DHL LOGISTICS FACILITY, BADGERYS CREEK (SOUTH)

STATE SIGNIFICANT DEVELOPMENT APPLICATION 1
TRANSPORT AND ACCESSIBILITY IMPACT ASSESSMENT

PREPARED FOR DHL SUPPLY CHAIN (AUSTRALIA) PTY LTD
31 JULY 2026 | 300303581

DHL BADGERYS CREEK
GROUND FLOOR
WAREHOUSE 3 & 4
COMPLIANCE REVIEW COMMENTS - OVERALL LAYOUT
DRAWING NO. 300303581-01-01 SHEET 01 OF 29 ISSUE P5

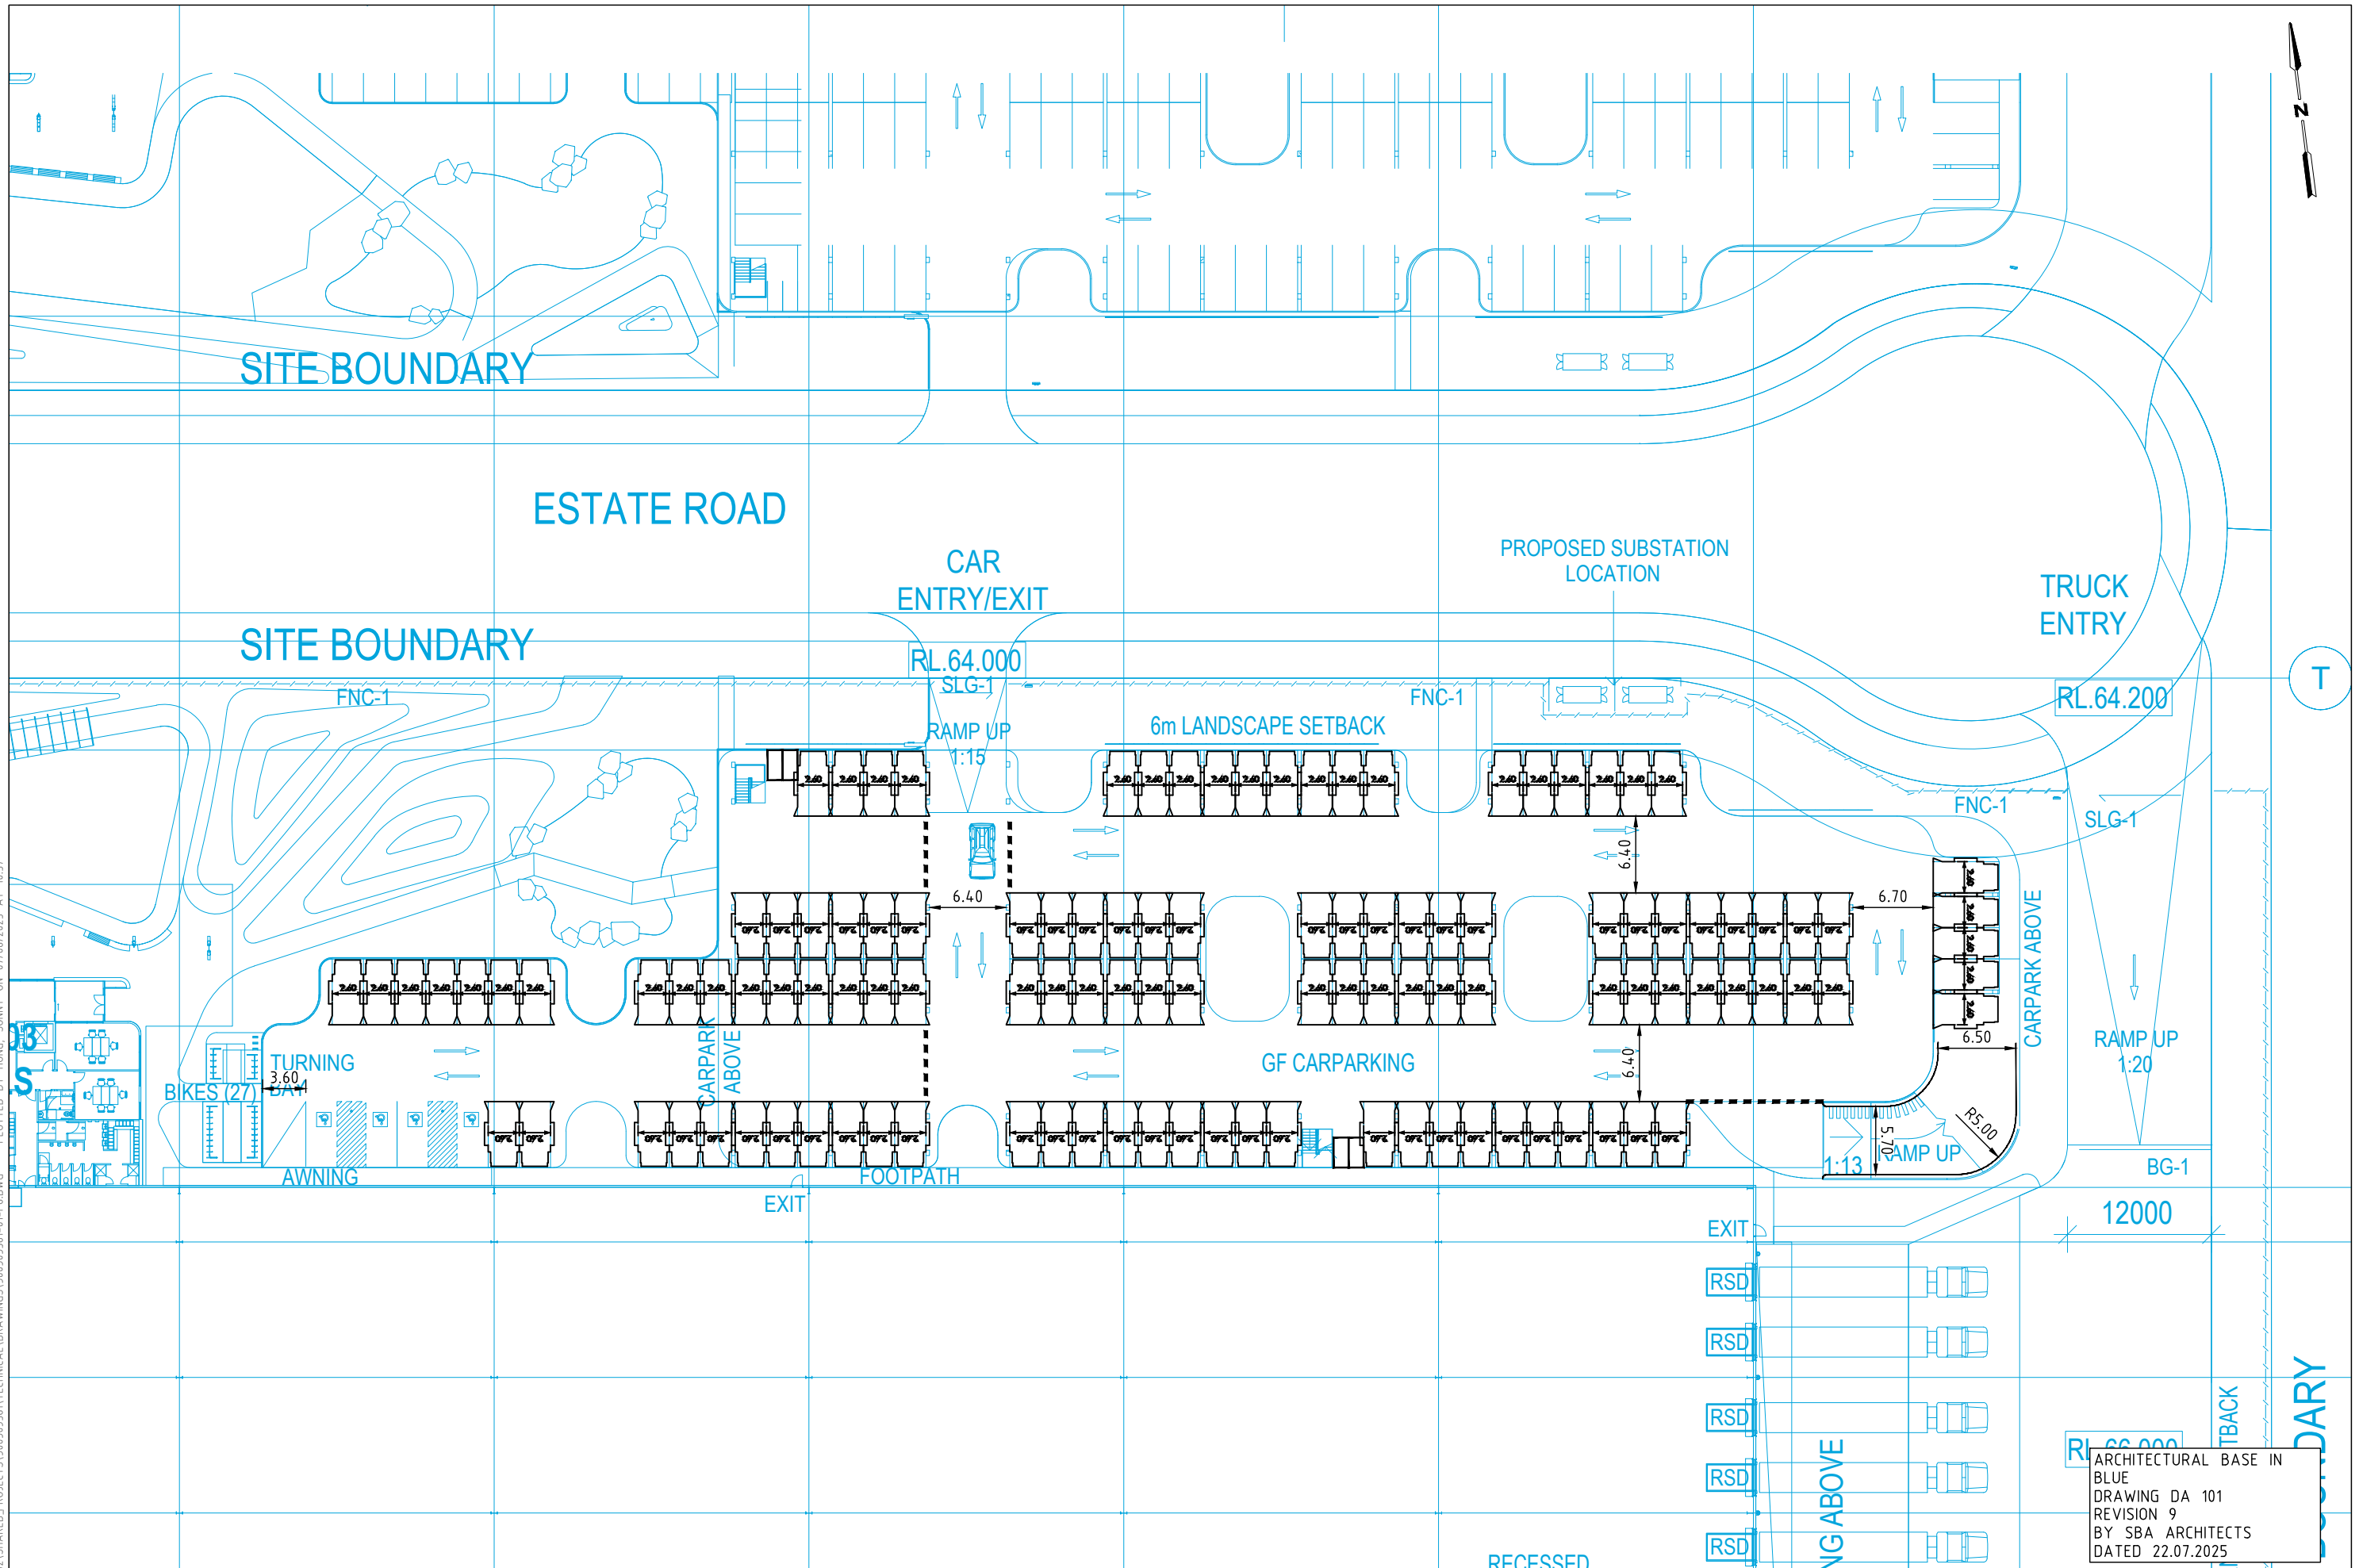
The architectural plans are not of sufficient detail (dimensions not provided for assessment purposes) to assess whether compliance with AS2890.2 has been demonstrated regarding all proposed truck entry/exit driveways.	Dimensions have been provided in updated architectural plans and Stantec's design review. Refer to Appendix A.
The architectural plans are not of sufficient detail (dimensions not provided for assessment purposes) to assess whether compliance with AS2890.1 has been demonstrated regarding car parking areas.	Dimensions have been provided in updated architectural plans and Stantec's design review. Refer to Section 6.4 and Appendix A.
The application does not state clearly that access and parking comply with AS2890.1, AS2890.2 and AS2890.6, but rather states that the site is expected to operate efficiently and safely, with heavy vehicle movements separated from light vehicle movements. Due to a lack of detail, it is not clear where non-compliances exist in this regard.	Refer to Section 6.4 of this TIA – the architectural plans have been reviewed against the AS2890 series and are generally compliant with the requirements. Car parking design is subject to change as part of the detailed design. We recommend this be addressed with a standard consent condition (i.e. traffic engineer to certify that the detailed design complies with AS2890 series prior to construction).
